INTERNAL MEMORANDUM

OBSERVATIONS BY THE ENGINEERING AND HIGHWAYS DIVISION IN RESPECT OF DEVELOPMENT AFFECTING EXISTING OR PROPOSED PUBLICLY MAINTAINED HIGHWAY

Outline application for erection of a mixed leisure development comprising Indoor Snow Centre (up to 39,200 sq m), Water park (up to 7,500 sq m), Indoor Activity Centre (up to 9,000 sq m), Outdoor Activity Centre, Hotel Accommodation (up to 418 bedrooms), Woodland Lodge accommodation (up to 30 units), car parking (up to 830 spaces) and associated earthworks, access, drainage, servicing and utilities connections/infrastructure at Land To The South West Of The A470/A4102 Roundabout At Rhydycar West Merthyr Tydfil

Figure 4.1: Expected Approach Flow Diagram

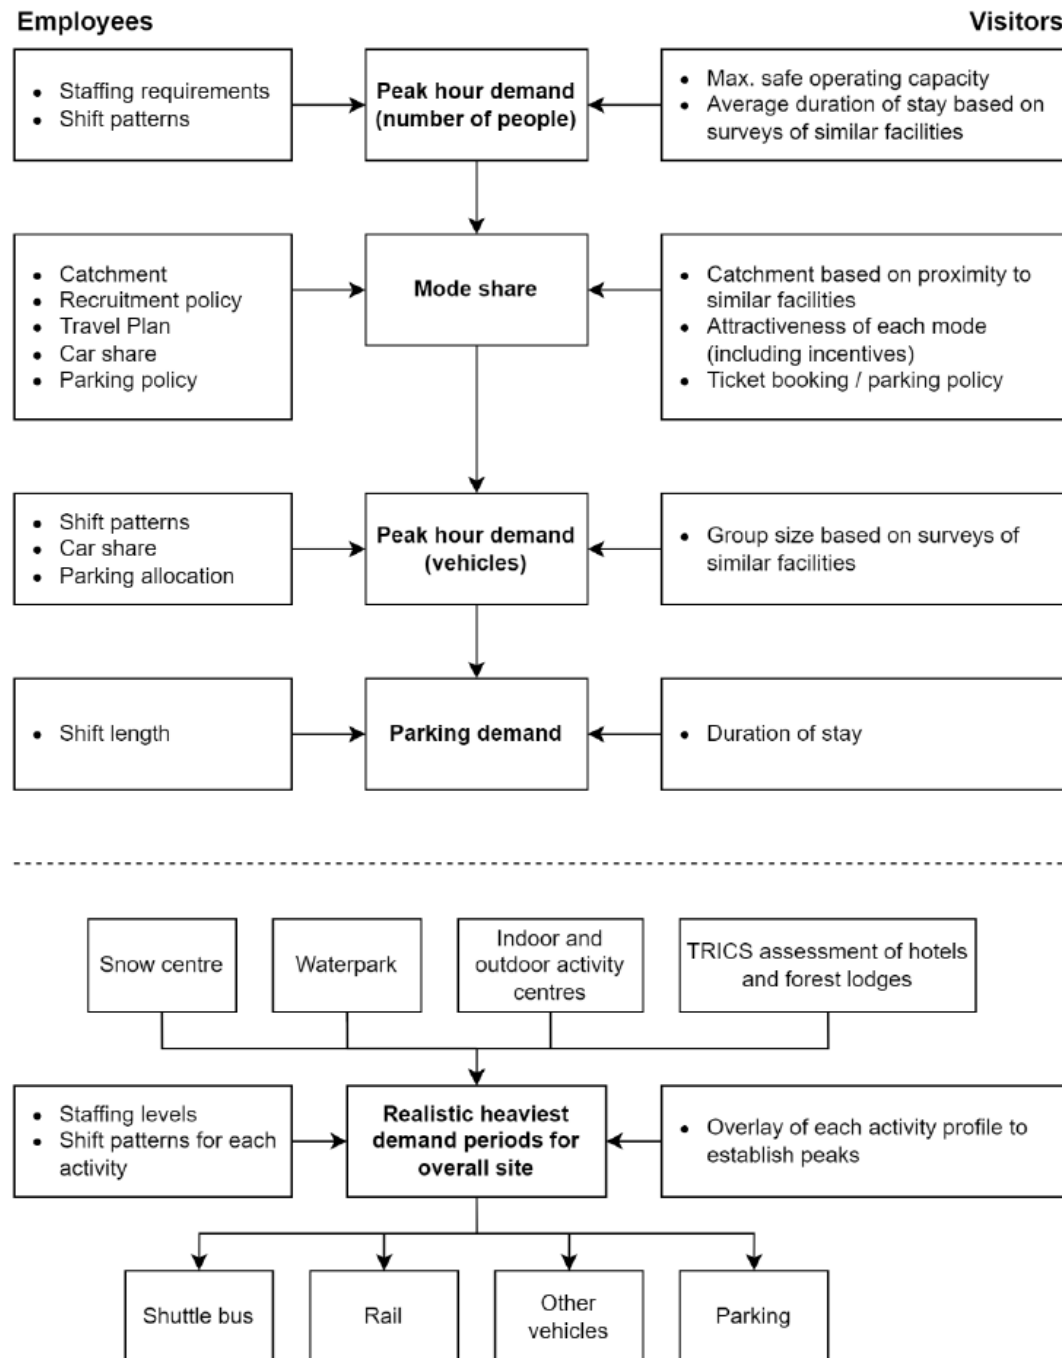
Secondly, there is no prescribed approach to the process of assessing transport impacts. A top-down or bottom-up approach which links to each stage should be undertaken, with the introduction of additional evidence/data at each stage and no unexplained gaps. Sensitivity assessments to understand the robustness of the calculations and the scale of impacts that variations in key estimates or assumptions may create.

Figure 4.1 below, extracted from the Mott Macdonald Review identify the expected approach to determine visitor/staff numbers:

The review summarises that whilst the submitted TA and TP are comprehensive and examine all aspects of the expected best practise and statutory guidance, most of the calculations are based on limited evidence to support key estimates and assumptions. As such, it is not possible to be confident that the derived figures for trip generation, parking needs and impact on the highway or public transport networks are realistic.

The review concludes that the submitted TA and TP do not adequately support the proposals with significant gaps in the evidence based as well as estimation process and hence the veracity of the predicted impacts. Significant additional data, explanation of the calculations and justification of underlying assumptions would be required before a robust assessment of the transport impacts and adherence to policy can be concluded.
